## QUALITY ASSURANCE -- NON-CONFORMANCE REPORT

**Report No:** NCR-000166

**Reference Description:** Incorrect welding of T Stiffeners Splice Backing

**Job Name:** SAS Superstructure

Below are two digital photographs illustrating this discrepancy.

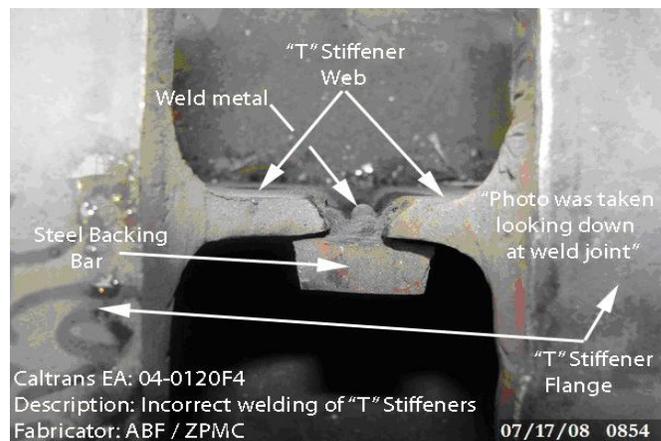
The Contractor performed welding that did not conform to approved working drawings and did not conform to workmanship requirements of the specifications. The Contractor performed welding with steel backing where it was not called out for in the approved weld detail. The Contractor performed welding that did not terminate in a manner to ensure sound welds. This was observed in the longitudinal T-stiffeners on side panel web splice SP069-001 of segment SEG 3AW.

Approved shop drawing Typical Weld Details, Sheet No. WD2, Weld Detail WD20AM

AWS D1.5, Sec. 3.12.1: "Welds shall be terminated at the end of a joint in a manner that will ensure sound welds."

ZPMC used back-up bar to complete this joint due to the root gap being too large for a pin back-up bar weld. ZPMC then removed the backing bar and performed inspections as required for this weld joint. ABF has instructed ZPMC to revise the Weld Detail if they anticipate this occurrence to repeat.

The response is acceptable, but the Non-conformance is not closed.

Please provide documentation of the weld inspections performed, and confirm that the associated shop drawings have been revised to show the as-built weld detail. The Department will review the Contractor's proposal to close Non-Conformance ZPMC-0153 at that time.

Below are two digital photographs illustrating this discrepancy.

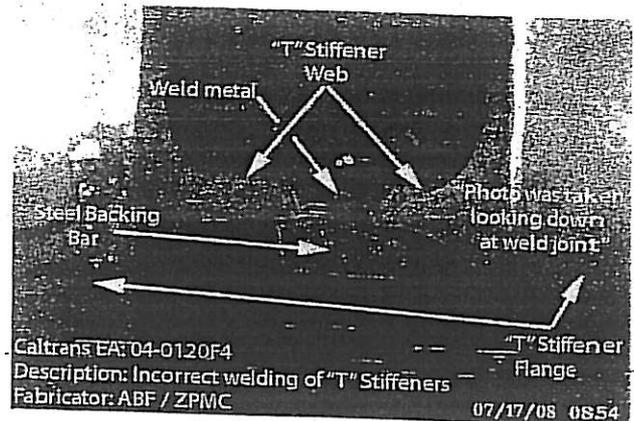
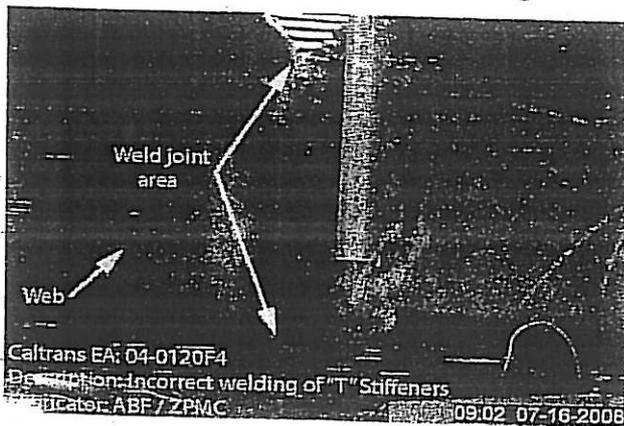
The Contractor performed welding that did not conform to approved working drawings and did not conform to workmanship requirements of the specifications. The Contractor performed welding with steel backing where it was not called out for in the approved weld detail. The Contractor performed welding that did not terminate in a manner to ensure sound welds. This was observed in the longitudinal T-stiffeners on side panel web splice SP069-001 of segment SEG 3AW.

Approved shop drawing Typical Weld Details, Sheet No. WD2, Weld Detail WD20AM  
 AWS D1.5, Sec. 3.12.1: "Welds shall be terminated at the end of a joint in a manner that will ensure sound welds."

The proposed resolution is acceptable. The welding repair report for the repair is included, and the welds in question have been accepted by VT and UT as shown in the attached documents. The Department concurs that Non-Conformance ZPMC-0153 is closed.

#### Draft of welding discontinuity:

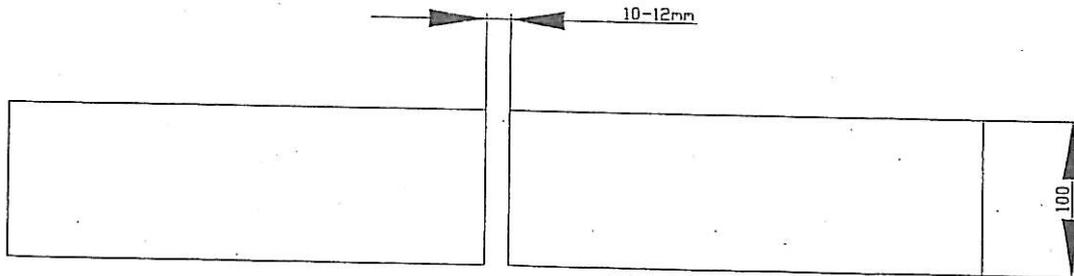
The butt gap of T rib of the 3AW segment bottom SP45B, SP57B and SP69B is 10-12 mm. The weld no. is SP045-001-051/052/053/054/055/056/057, SP057-001-064, SP069-001-056.

The operator performed mistakenly when cutting the tolerance, leading to the butt gap between T-ribs over the requirement.

1. Prepare excavation with relevant WPS.
2. VT and MT to verify repair area is free of all defects.
3. Add steel backing at the back of groove according to AWS D1.5.3.13;
4. Preheat and weld according to the relevant WPS.
5. Gouge off the steel backing and grind the weld flush with base metal after welding;
6. Perform NDT inspection of the weld according to the working drawings.
